TO: Planning Board/Zoning Board of Appeals
FROM: OSPCD Staff
SUBJECT: 360 Foley Street ZP25-000120 & ZP25-000121
POSTED: February 26, 2026

RECOMMENDATION: Approve with Conditions (Major Amendment to PUD-PMP)
Approve with Conditions (Major Amendment to SPSR-A)

Assembly Row Hotel LLC proposes a Major Amendment to the Updated Block 5 Design Guidelines and existing PUD (PB 2006-59) in the Assembly Square Mixed-Use District (ASMD).

Assembly Row Hotel LLC proposes a Major Amendment to a previously issued SPSR-A (PB2014-34) in the Assembly Square Mixed-Use District (ASMD).

(PPZ Staff Note) Figure 2 - Current Approved Block 5 Design Guidelines

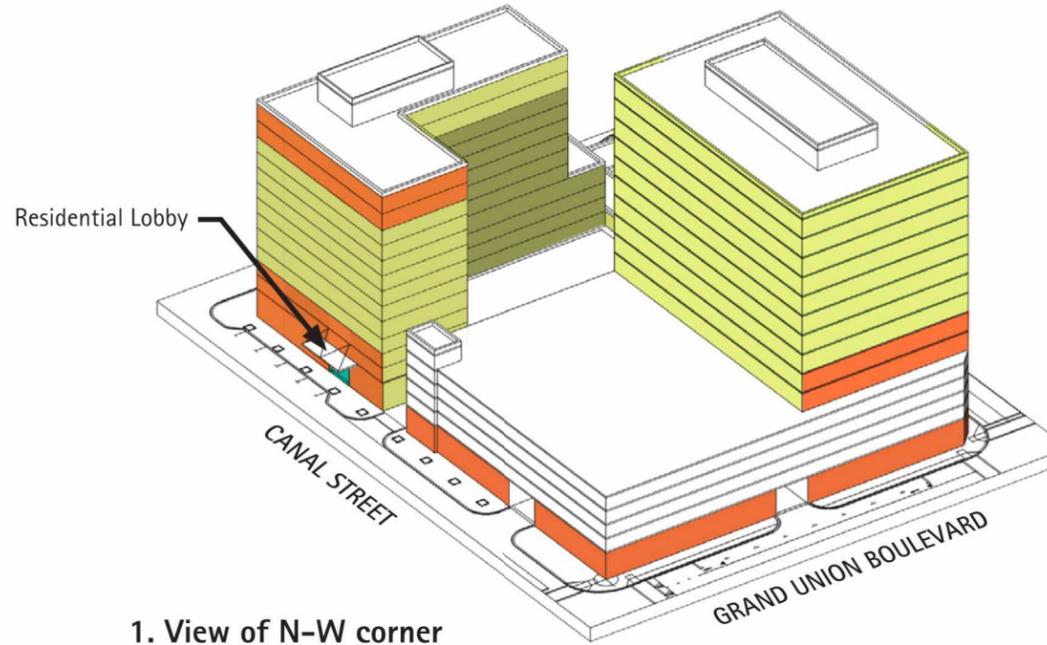
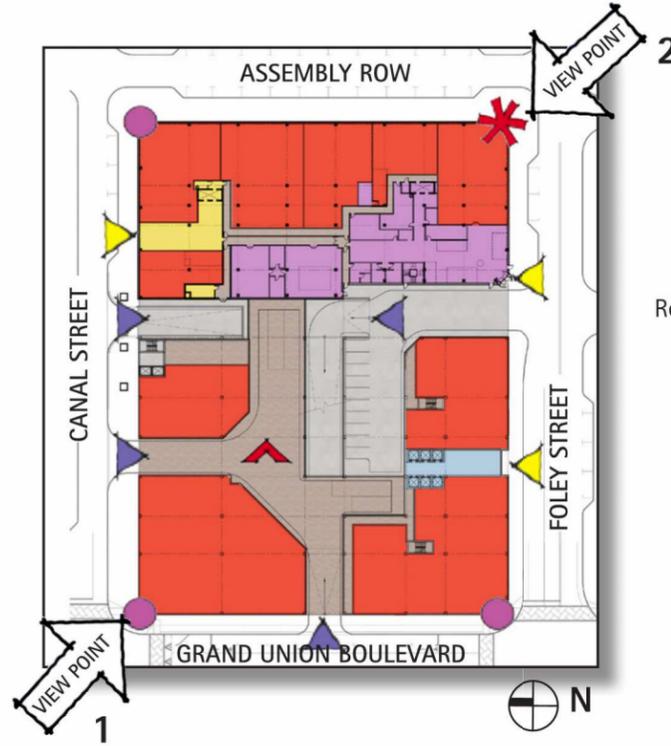
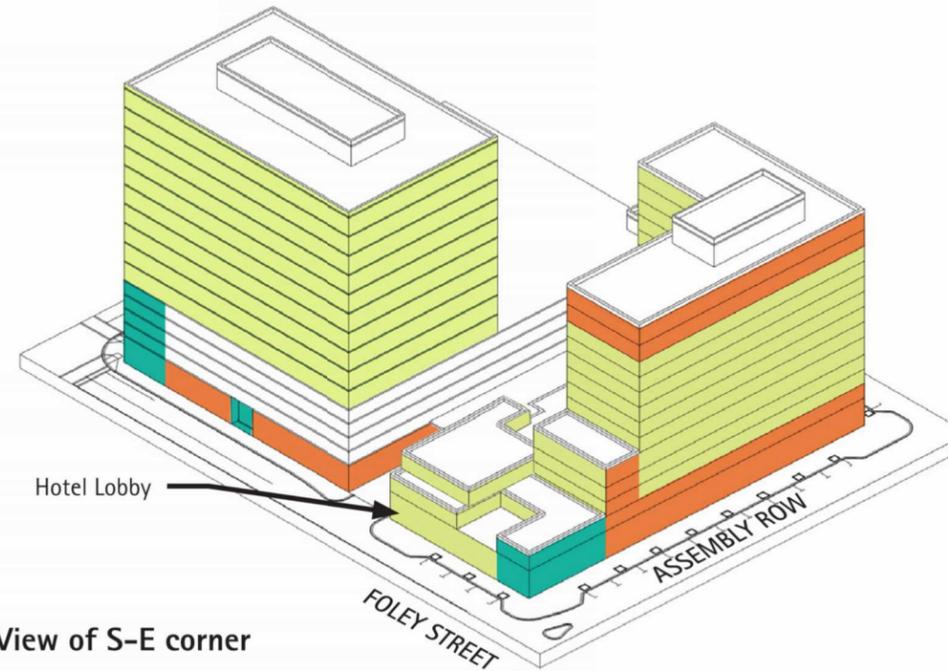
The proposed Design Guidelines do not make any changes to the hotel keys, residential units, parking and approved ground floor retail/restaurant spaces. Below figures 1 and 2 are marked to show the minor design changes which only focus on accommodating the flow of the hotel access in relation to the change of the lounge to a higher floor. None of these changes impact any findings made in the PUD.
